# Investigation of Pipelines Integrity Associated with Pump Modules Vibration for Pumping Station 9 of Alyeska Pipeline Service Company

October 2009

Prepared by  
John Jy-An Wang,  
Oak Ridge National Laboratory

#### **4. Review Comments on EDI Report 93393-1 regarding PS09 and PS03 Vibration Investigation**

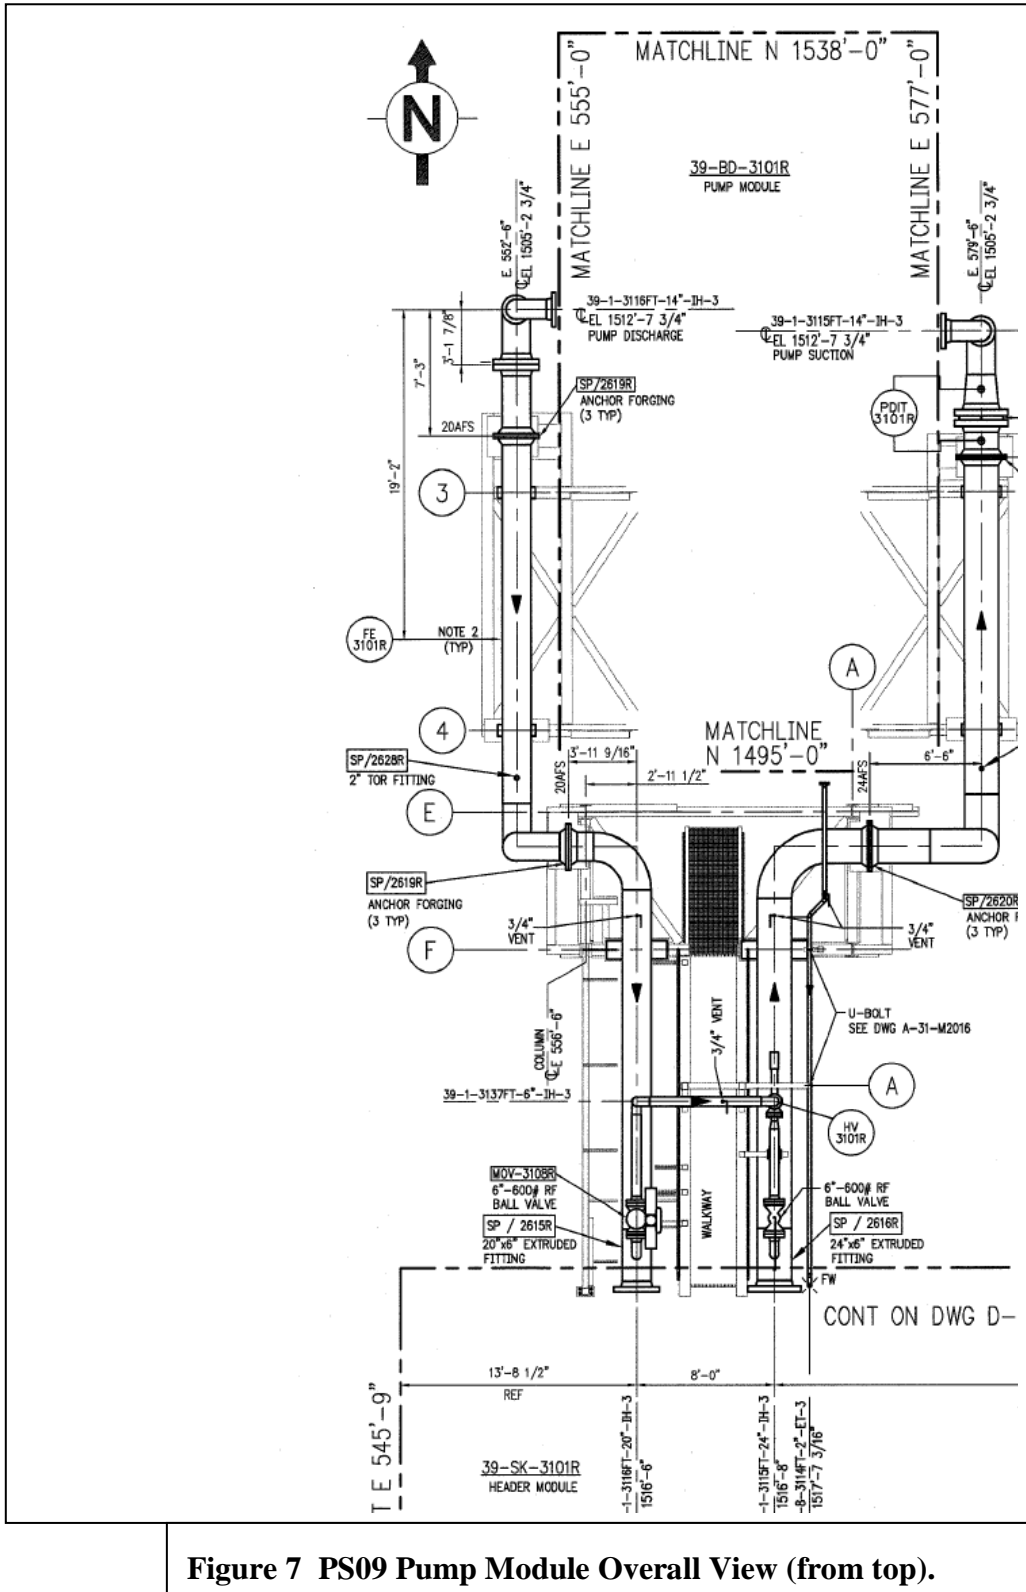
##### **(1) Hydrostatic and hydrodynamic forces are induced by the pump to the PS09 Module**

Based on Fig. 7, the inlet and outlet pump nozzles are at the same elevation, but with a 1.28-ft offset in the N-S direction. From Fig. 12 of the EDI report, the pump inlet and pump outlet pressures remain constant and are 100 psi and 820 psi, respectively, during PS09 pump operation. Both pump inlet and outlet pipe diameters are 14-in. The net force input (in the E-W direction) by the hydraulic pump that is applied to the PS09 module system is equal to

These are the pump induced hydrostatic loads on the PS09 module.

The hydrodynamic induced forces are from the pulsation pressure. Based on Fig. 13 of the EDI report, the maximum pulsation pressures for the inlet and outlet pipes of the pump are 40 psi and 13 psi, respectively. Assuming that that the inlet and outlet pulsations are out of phase to each other, this results in maximum dynamic forces to the PS09 module system.

- (2) Hydrostatic and/or hydrodynamic forces are induced by the piping system configurations to the PS09 Module

The pipe loop configurations, including all the pipe fittings, such as: elbow, reducer, and valves, will contribute to this category of forces. For demonstration purposes, the hydrodynamic force applied to the first elbow downstream of the pump is used as an example. For a 12,600 GPM flow at first elbow, (assuming that there is not much pressure variation at the first elbow inlet and outlet locations), the pressure is about 800 psi; the estimated resultant force components (at x and y-axis orientations) applied to the elbow can be written as below.

The associated resultant force  $F_R$  is equal to 337,660-lb, at 45° angle (vertical) to the elbow.

These hydrostatic and hydrodynamic forces and torques are significant and all need to be properly transmitted to the vertical supporting structure (VSM) of the PS09 module to ensure stability and safe operation of the pump and the associated piping system, i.e., the designed VSM of PS09 module must have sufficient stiffness and strength to cope with these hydrostatic and hydrodynamic forces generated by the pump and the associated piping systems.

**Figure 11 The piping system of PS09 and the associated piping constraints locations**

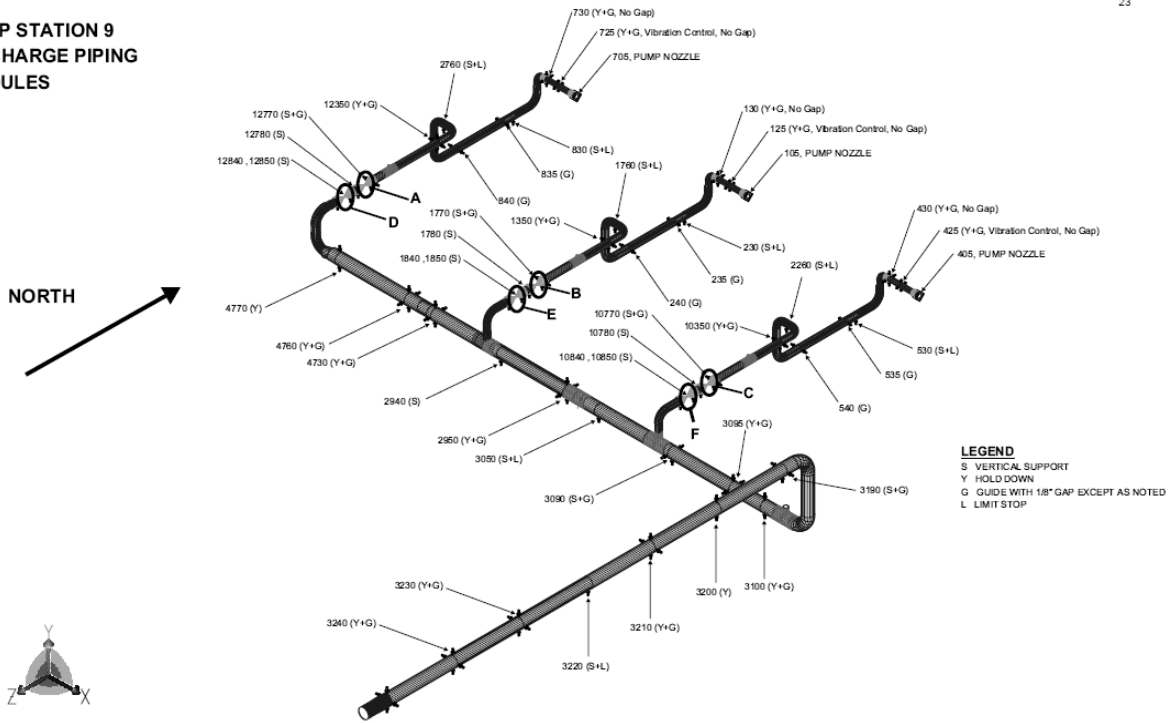
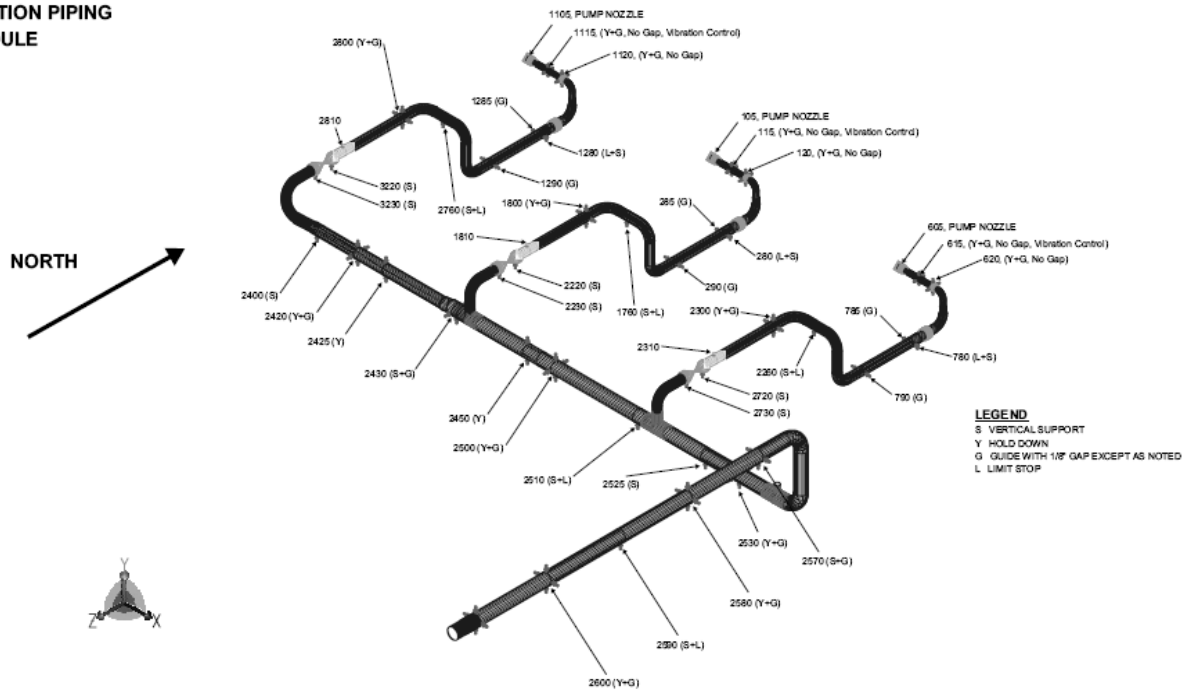
- (1) In EDI modal analyses, I would like clarification on whether the piping constraints (shown in Fig. 11) in both suction and discharge lines were properly implemented and taken into account in the modal analyses. Also what was the damping ratio of piping used in this analysis?
